# How to update T32MZ

Your Futaba T32MZ transmitter programming can be updated easily and at no cost online. When functions are added or improved, the update file can be downloaded from our website. Copy the update files to the microSD card and then use the following procedure to update the program.

**1. Failsafe Delay function newly added.**

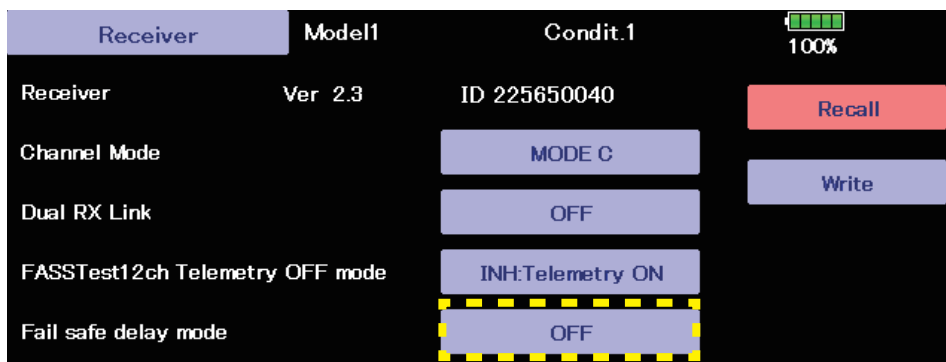
By connecting a receiver that supports the failsafe delay function, can turn the fail-safe delay function ON/OFF.

This function enables the servo movement softly toward the preset failsafe position when the failsafe activated.

Also when back to normal operation the servo movement softly back to the position of under controlled.

To enable this function, please go to Receiver Setting menu in the "System Menu" of the transmitter.

This delay function is valid for all channels set failsafe and not able to set each channel independently.

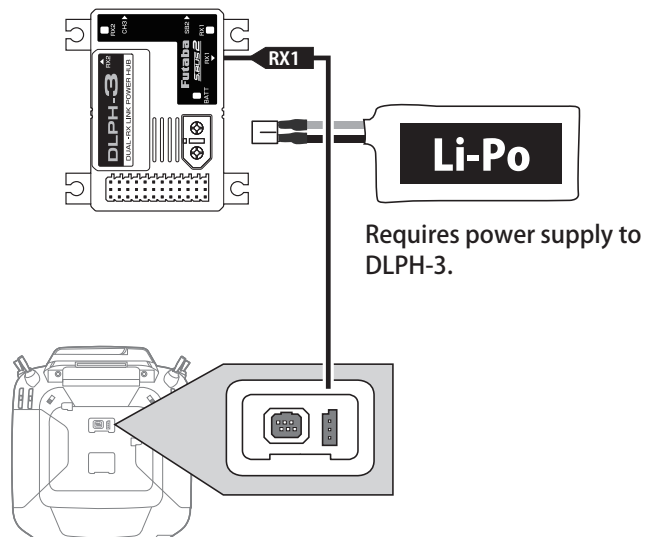
Added Vector Nozzle function for jet models.

Camber mixing setting rate has been expanded from  $\pm 100$  to  $\pm 200$ .

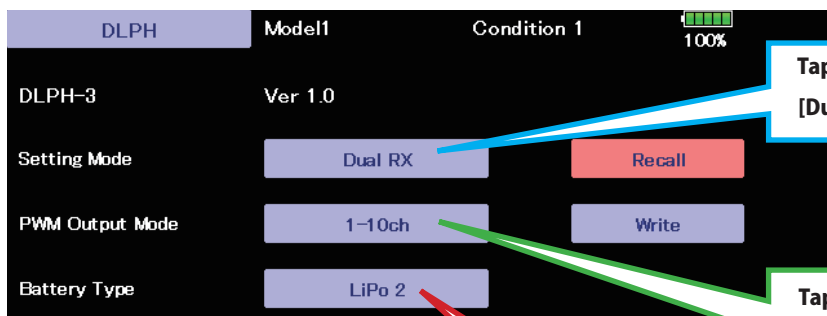
Tapping the Setting mode switches as follows:

[Dual Rx] → [Single Rx] → [Airplane Gyro] → [Dual Rx] → ...

When the setting mode is set to [Airplane Gyro], the PWM output mode is fixed to [1-10ch].

Tapping the PWM output mode switches as follows:

[1-10ch] → [11-20ch] → [21-24ch] → [1-10ch] → ...

Tapping the Battery type switches as follows:

[LiPo 2] → [LiFe 2] → [LiPo 3] → [LiPo 2] → ...

## 1. Telemetry settings: Added gear ratio setting button to Kontronik ESC and Scorpion ESC.

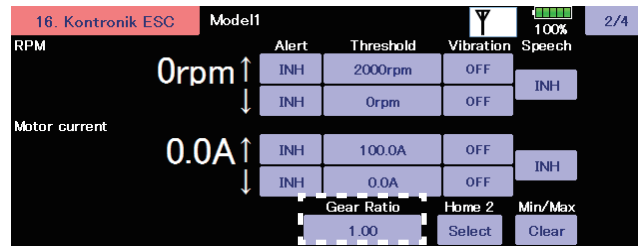
•If the gear is down, enter the gear ratio to display the helicopter rotor speed and the airplane gear down propeller speed.

## 2. Telemetry settings: Changed the motor pole number setting for each ESC to "100".

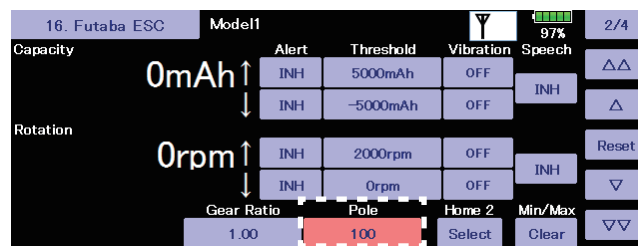
Previously, the number of poles was up to 36, but now it can be set up to 100.

•Enter the number of poles for your motor.

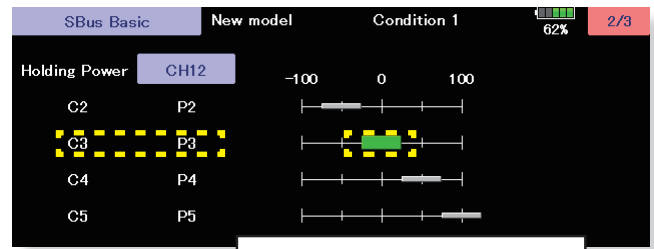
Like the flight condition function of the transmitter, you can set up to 5 different data for the attitude holding force rate of the aircraft in AVCS mode by operating the switch from the transmitter, and switch between them. You can set the holding power rate selector switch to the channel with the AFR function of the transmitter, and set the point for each rate on the AFR point curve to switch. It is also possible to use the flight condition function to work with the flight condition switch.

## 2. Add R.P.M. display : Gov Basic

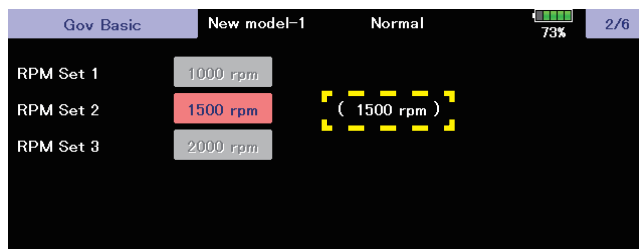
The number of revolutions of the governor setting is displayed on the governor basic screen of the gyro setting.

## 3. GYA553 Addition of setting parameters

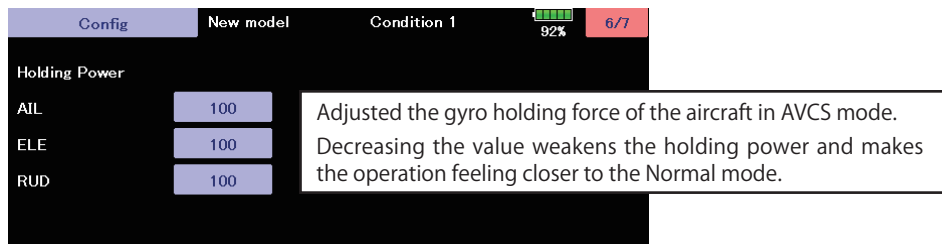
AIL / ELE / RUD holding power setting has been added to the setting parameters of GYA553.

## 4. Expansion of governor R.P.M. range

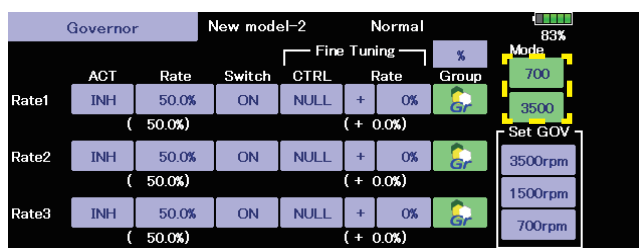
With the governor function of the model menu, the R.P.M. range has been expanded to 700 to 3500 rpm.

### 1. Add Screen off function [Quick start]

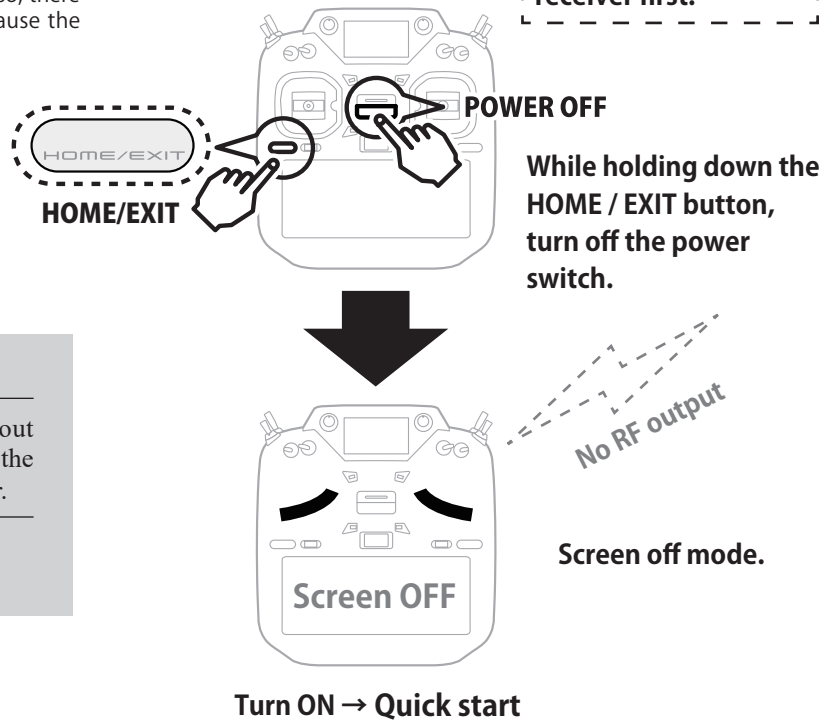
This "screen off" can quick start next startup. This is convenient when turning on and off frequently. No RF output at "screen off". Also, there is no screen display. However, the battery is consumed because the internal circuit is activated.

Be sure to turn off the receiver first.

- ⚠ While in screen off mode, it consumes about 4% of the battery per hour. If you do not use the transmitter for a long time, turn off the power.
- ⚠ Updates cannot be performed in screen off mode. To update, turn off the power.
